Air Quality Permitting Response to Public Comments

**Permit to Construct No. P-2015.0049
Project 61596**

**Alta Mesa Services, LP
Kauffman 1-9
New Plymouth, Idaho**

**Concentration Contours in micrograms per cubic meter
 Combined Impacts of Kauffman 1-9 and ML Investments 1-3
 for 1-Hour NO2 Design Value Impacts
 Background Concentrations not Included**

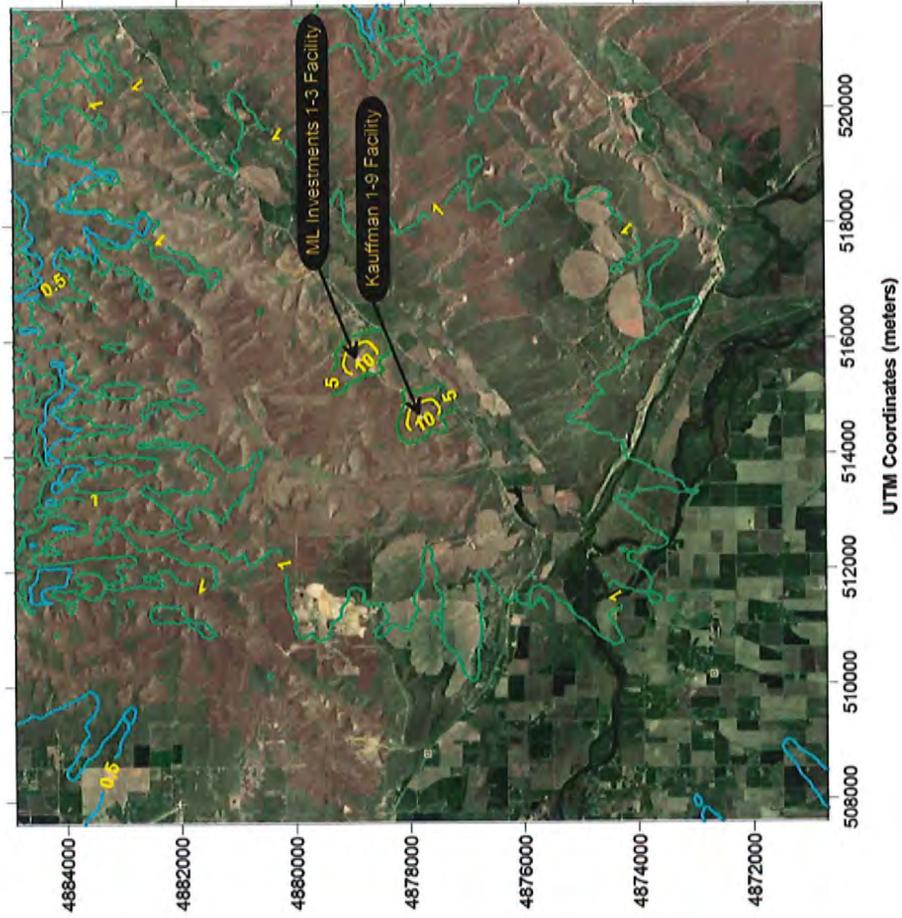
Comment 2: We strongly encourage DEQ to aggregate emissions from this well with all of the current or future wells within this valley. DEQ air impact modeling results highlight that emissions from these well sites have broad dispersions, impacting air quality up to 7 miles away from the source (see Figure 1 in DEQ’s Modeling Memorandum). The emissions from these wells will undoubtedly combine in the atmosphere and have a cumulative impact greater than what is predicted solely analyzing each well site as an individual entity. Treating each well site does not capture the whole picture, and may inadvertently fail to predict harmful air quality violations as a result of cumulative impacts.

DEQ also disagrees with the comment stating that emissions from this site should be aggregated with all current or future wells within this valley when evaluating the air impacts. Within approximately 0.4 miles, design value (equal to the 5-year average of upper 98th percentile impacts of the annual distribution of maximum daily 1-hour impacts, consistent with the form of the 1-hour NO₂ standard) drops to levels below 10 µg/m³. Within about 3 miles, design value impacts drop to levels below 1.0 µg/m³ at most locations.

DEQ analysts, responsible for evaluating air impact analyses of potential emissions from facilities applying for air emissions permits, conclude that it is unlikely a similar neighboring facility located outside of ¼ mile could have a measurable effect on the maximum design value impact for the 1-hour NO₂ standard. This is based on the magnitude of NO_x emissions from the well site facilities. The plume of the two sources must overlap almost exactly during a period when the primary source has relatively high impacts to enable a measurable co-contributing impact for a 1-hour averaging period. The probability of this is small for sources separated by more than ¼ mile. Also, the conservative manner in which background concentrations are considered in the analyses, using the design value concentrations for both the modeled impact and the background concentration, provides an adequate level of NAAQS compliance assurance.

To demonstrate the impact of nearby well sites on the maximum modeled design value of a particular well site, DEQ performed an analysis of combined impacts from Kauffman 1-9 and nearby well-site ML Investments 1-3. The ML Investments 1-3 site has the same type of equipment and identical projected maximum emissions rates as the Kauffman 1-9 site, and it is located about 0.7 miles northeast of the Kauffman 1-9 site. Inclusion of the ML Investments 1-3 site did not change the value of the maximum design value impact of the Kauffmann 1-9 site, and the effect at most locations other than areas very near the ML Investments 1-3 site was negligible. The figure below compares design value impacts for the Kauffman 1-9 site to those of the combined ML Investments 1-3 and Kauffman 1-9 site.

**Figure 1: Concentration Contours in micrograms per cubic meter
 for 1-Hour NO2 Design Value Impacts
 Background Concentrations not Included**

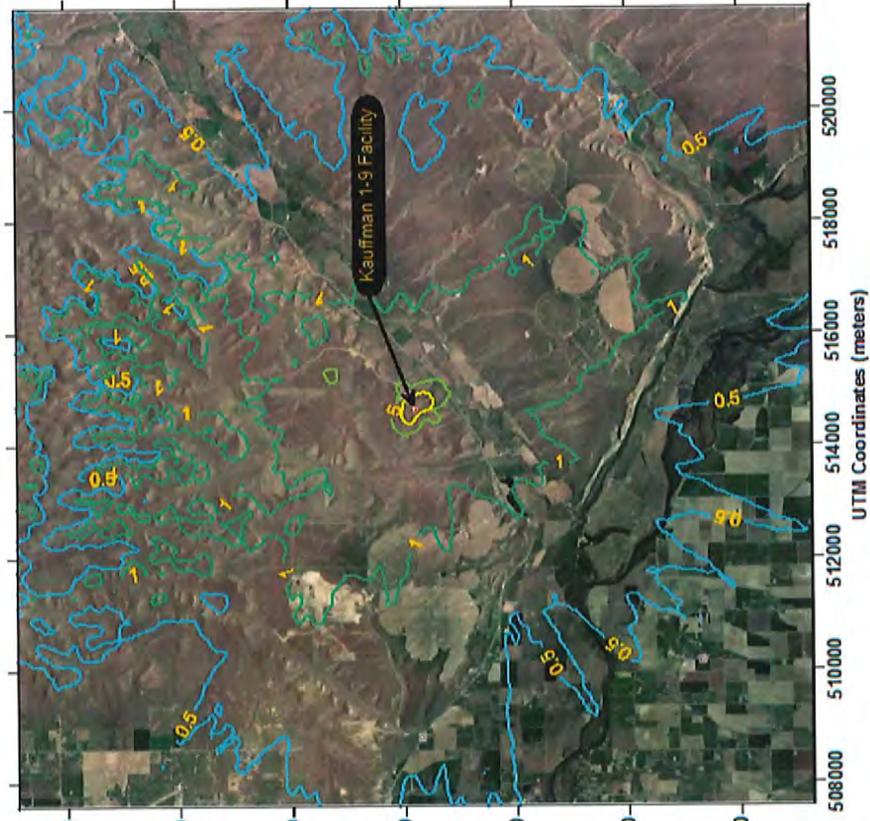
Results from NAAQS impact modeling for the Kauffman 1-9 well indicate that emissions from this source will span roughly 7 miles (see Figure 1 in DEQ's Modeling Memorandum). The majority, if not all of these wells will reside within the 1 $\mu\text{g}/\text{m}^3$ increase in 1-hour NO_2 contour. As a result portions of the valley within the immediate vicinity of all of these wells will experience at a minimum an increase in 1-hour NO_2 concentrations of 6 $\mu\text{g}/\text{m}^3$, bringing background concentrations for 1-hour NO_2 up to at least 58.6 $\mu\text{g}/\text{m}^3$. This increase could have serious implications if wells have total maximum concentrations modeled close to the NAAQS threshold.

If not done so already, DEQ should account for increases in background levels of 1-hour NO_2 concentrations in order to appropriately demonstrate compliance with the NAAQS. We believe the air impact modeling has not adequately demonstrated compliance with the NAAQS if current model predictions did not account for these future known increases in background concentrations.

The modeled design value contour map for the Kauffman 1-9 facility cannot be interpreted as an appropriate contribution to general background pollutant levels. The design value is based on the 8th highest value of daily maximum 1-hour concentrations. For this value to contribute to design value impacts of other facilities, the impacts would need to coincide in time and space with the impacts of other facilities and periods of high regional background concentrations. This is highly unlikely.
